Access Compliance Report Public Rights-of-Way (Curb Ramps)

Intersection ID: 5808	Main Street: FOREST_POND_DR	Cross Street: NEVIN_RD	Location: SE
ADA ID: E952EDFBA2CF	Ramp Type: Perp	Initial Pass/Fail: Fail	Overall Compliance: No Severity Score: 1.25

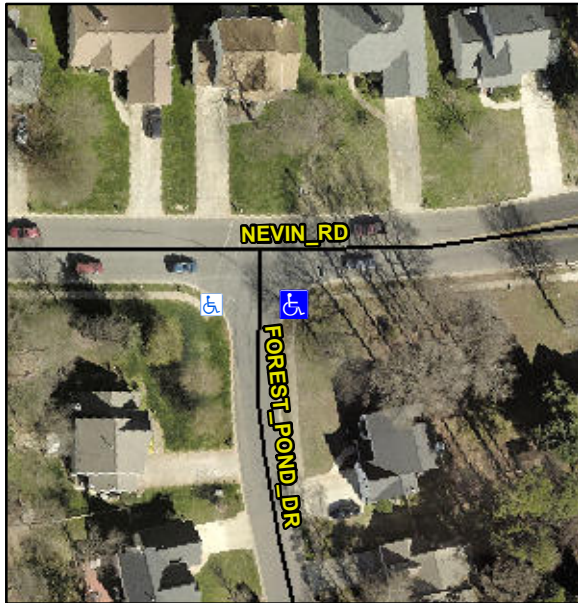
Not Found, R304.5.3

Compliance	Description	Data	Compliance	Description	Data
N/A	Ramp Length (in)	47.0	Yes	Ramp Slope (%)	8.1
Yes	Ramp Width (in)	48.0	No	Ramp XSlope (%)	3.9
N/A	Flare Type LT	N/A	N/A	Flare Type RT	N/A
N/A	Flare Slope LT (%)	N/A	N/A	Flare Slope RT (%)	N/A
N/A	Flare Traversable LT?	N/A	N/A	Flare Traversable RT?	N/A
N/A	Landing Length (in)	N/A	N/A	DWS Provided?	N/A
N/A	Landing Width (in)	N/A	N/A	DWS Contrast?	N/A
N/A	Landing Slope (%)	N/A	N/A	DWS Length (in)	N/A
N/A	Landing X Slope (%)	N/A	N/A	DWS Full Width?	N/A
N/A	Landing Curb? (Y/N)	N/A	N/A	DWS Offset (in)	N/A
N/A	Shared Landing?	N/A			
N/A	Gutter Ponding?	N/A	N/A	Gutter Slope (%)	N/A
N/A	Gutter Lip Ht (in)	N/A	N/A	Gutter X Slope (%)	N/A
N/A	Painted X Walk1?	No	N/A	Painted X Walk2?	N/A
	X Walk 1 Direction	To W		X Walk 2 Direction	N/A
N/A	X Walk 1 Width (in)	N/A	N/A	X Walk 2 Width (in)	N/A
	X Walk 1 Slope (%)	2.6		X Walk 2 Slope (%)	N/A
	X Walk 1 X Slope (%)	4.4		X Walk 2 X Slope (%)	N/A

Remove & Replace Entire Ramp.
